PLAN-010656

Proposal: Replacement of existing mansard garage roof with new pitched roof & conversion of former garage into ancillary residential accommodation to main dwelling.

Site: Church Farm House, Church Lane, Yapton, BN18 0EP.
Y/53/15/HH

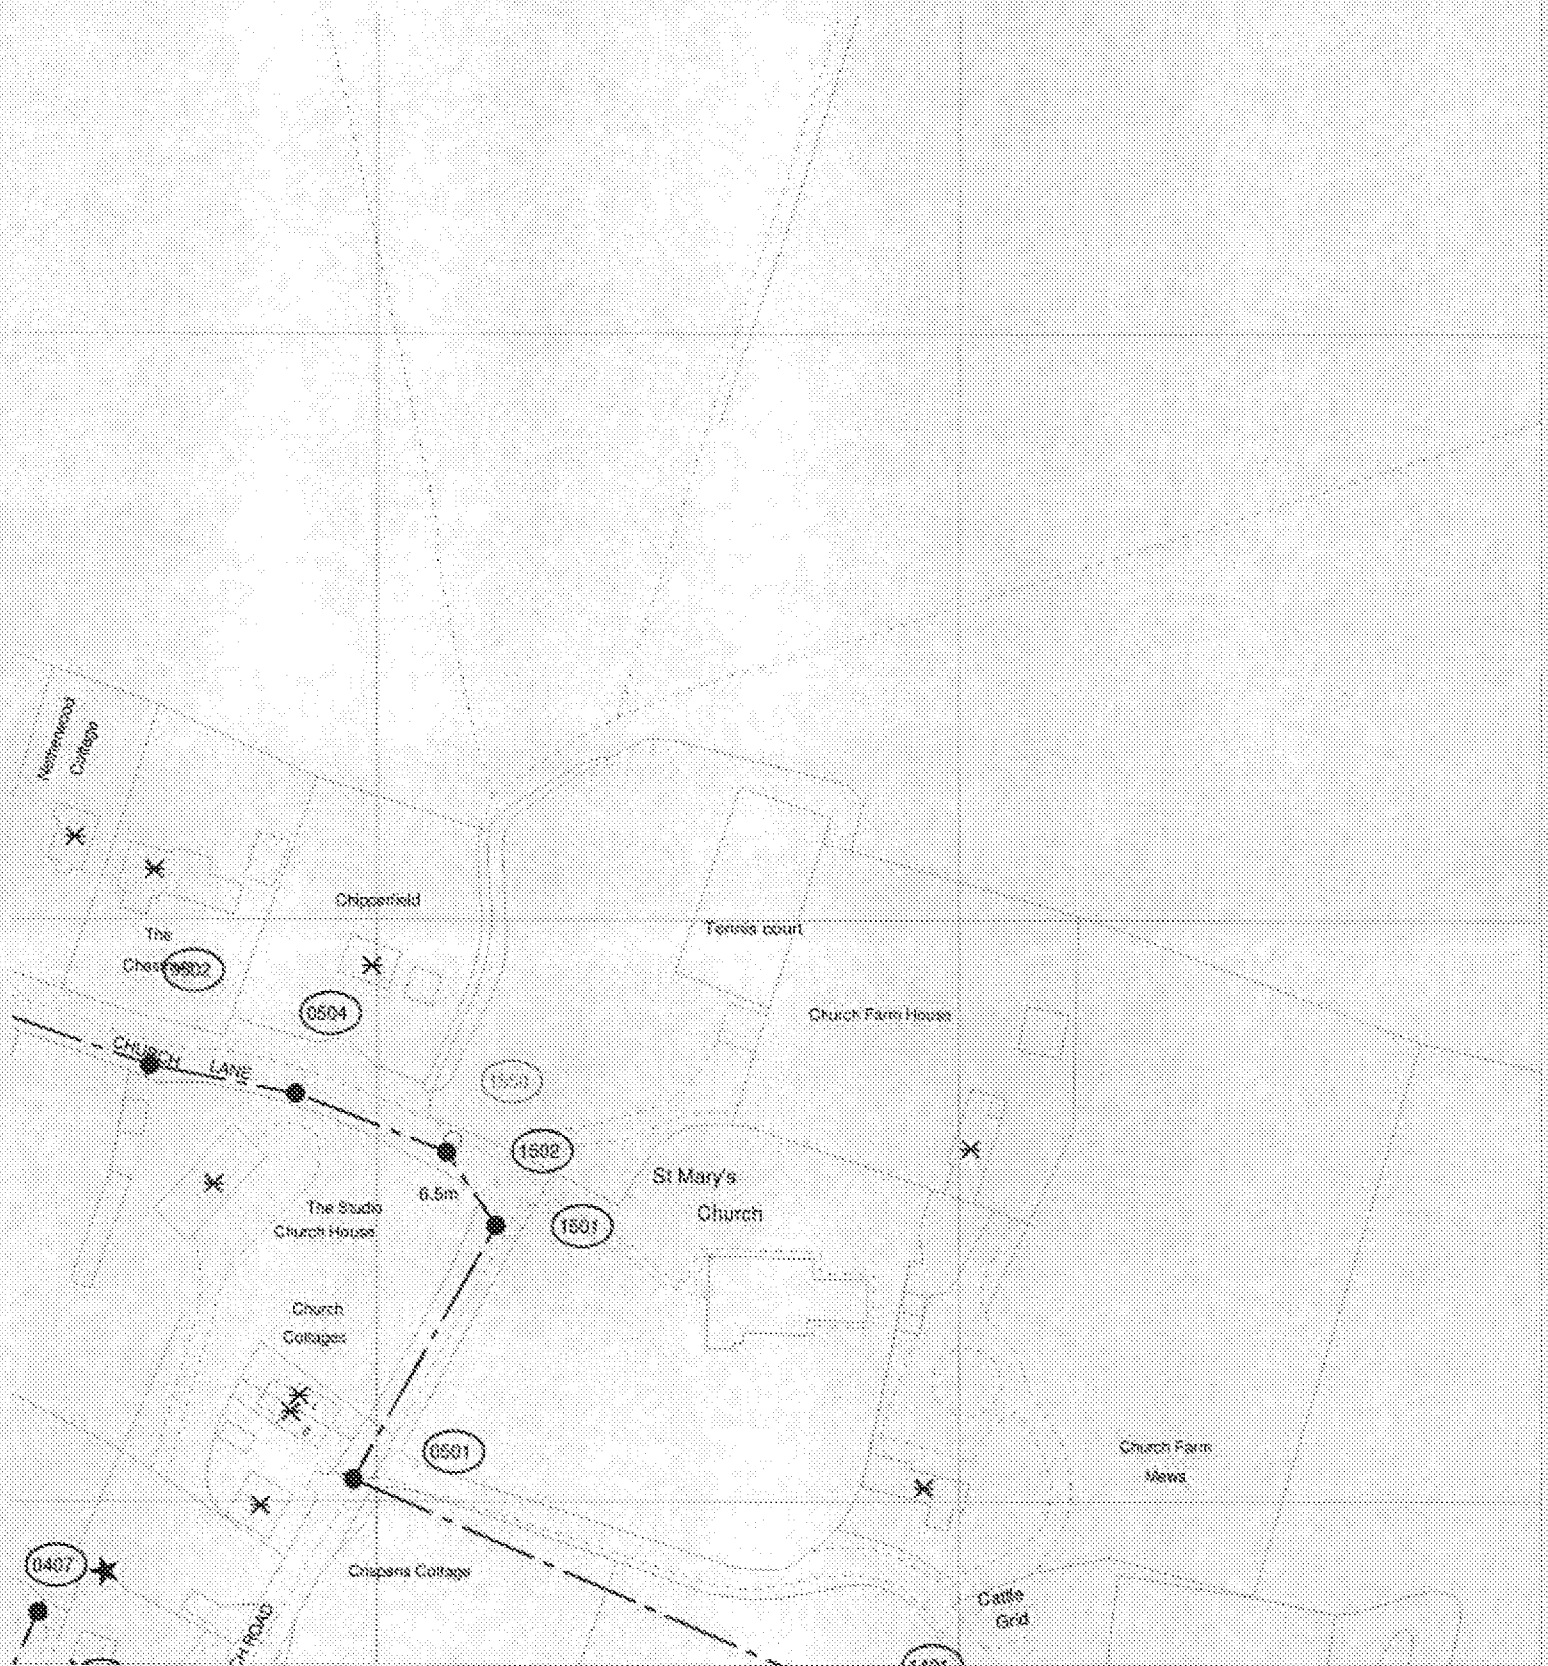
Our initial investigations indicate that there are no public surface water sewers in the area to serve this development. Alternative means of draining surface water from this development are required. This should not involve disposal to a public foul sewer.

Due to changes in legislation that came in to force on 1st October 2011 regarding the future ownership of sewers it is possible that a sewer now deemed to be public could be crossing the above property. Therefore, should any sewer be found during construction works, an investigation of the sewer will be required to ascertain its condition, the number of properties served, and potential means of access before any further works commence on site. The applicant is advised to discuss the matter

Due to surface water inundation issues in the Lidsey Catchment "The applicant is advised to adopt, where appropriate, the measures in the table "Practical measures to reduce the potential impacts of development".

Developer should look to protect the public sewerage system from inundation and infiltration, which contribute to flooding in unfavourable conditions.
